Service Bulletin

Product Family: 920 Series Sno-Tek™ Snow Throwers

Subject: LCT Engine Missing Safety Shield

Technical Service Bulletin

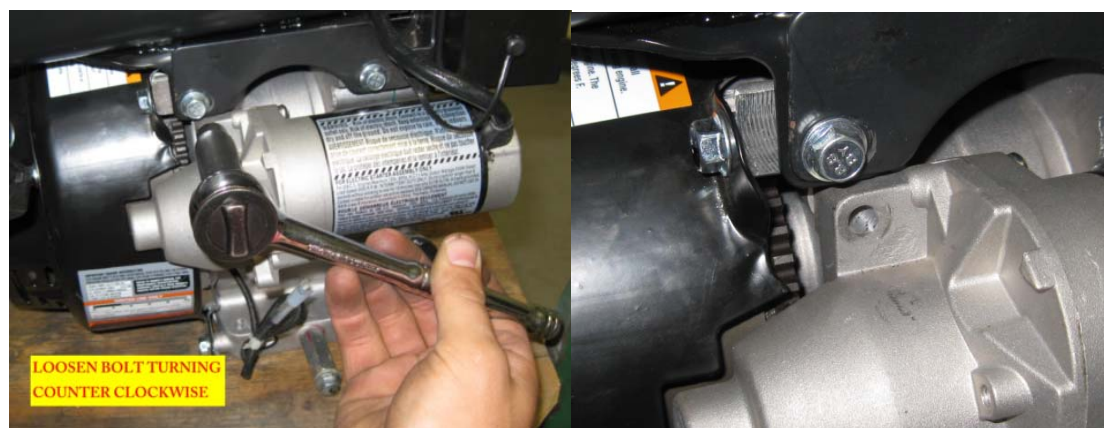
1. Visually inspect engine to verify shield is present (see picture below). If shield is present, no further action is required.

2. If it is determined the proper shielding is not present (see picture below), please contact LCT USA customer service at 800-552-8094 and a service kit will be provided to correct the issue. When contacting LCT USA customer service please have the following information available: Ariens product model and serial numbers and LCT engine model and serial numbers.

SUPPLIED
SHIELD

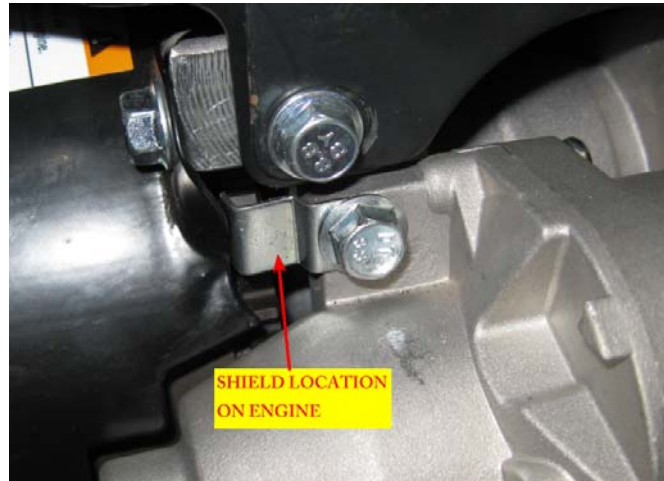
2. Re-install the top electric starter mounting bolt with the supplied shield located in between mounting bolt head and starter body.

3. Tighten the bolt in a clockwise rotation using a torque wrench to a torque value of 10-12 n-m (86-106 in-lbs).
